The Ridge at Winterset Summit Rezoning and Preliminary Development Plan

PL2020-219

Date 10-22-2020

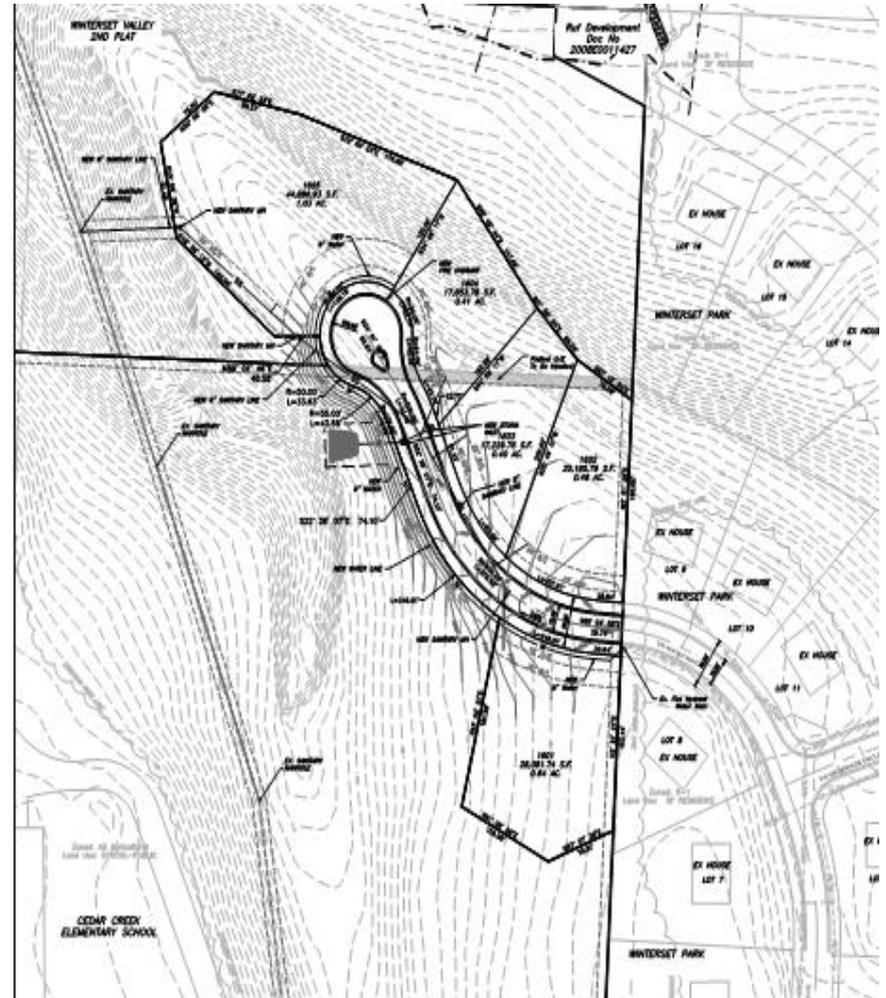
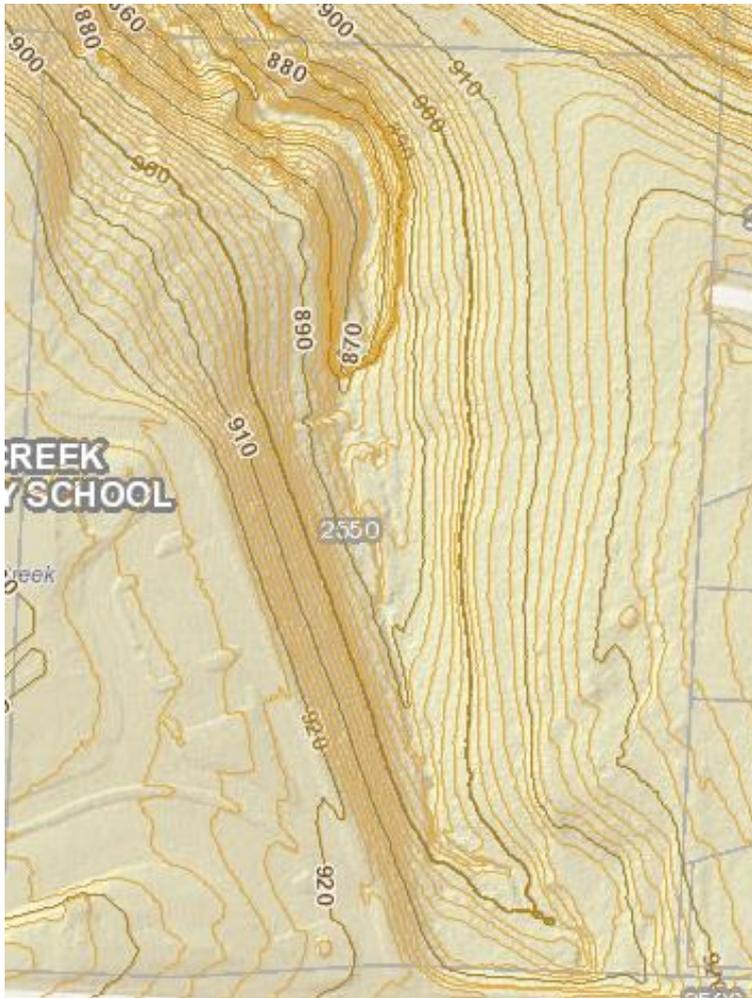
- Required -A subdivision shall consist of no more than 10% cul-de-sac lots.
- Existing-Winterset Park, 45 existing lots, 8 of them on a cul-de-sac.
- Proposed –The Ridge at Winterset Summit, 5 lots, all of them on a cul-de-sac.
- Total lots-50, 13 will be on a cul-de-sac.
- The resulting 26% cul-de-sac lot composition exceeds the allowed 10% of total for a subdivision.

- Required – R-1 single-family residential front yard set backs are to be no less than 30 ft.
- Proposed – 5 new lots that are being proposed, 3 of the lots will need a modification.
- Lots 2 and 3 are requesting a 25' setback.
- Lot 4 is requesting a 20' set back.

- A modification shall be granted to the 10% maximum allowance of cul-de-sac lots in a subdivision, to allow a combined 26% cul-de-sac lots between The Ridge at Winterset Summit and Winterset Park subdivisions.
- A modification shall be granted to the minimum 30' front yard setback requirement, to allow the requested 25' for Lots 2 and 3, and 20' for Lot 4 for The Ridge at Winterset Summit subdivision.
- Added Standard Condition
 - Certain aspects of the development plan related to stormwater management will be further reviewed during the Final Plat phase of the project. This includes detailed aspects of the design to help ensure that the plan meets the design criteria and specifications contained in the Design and Construction Manual.
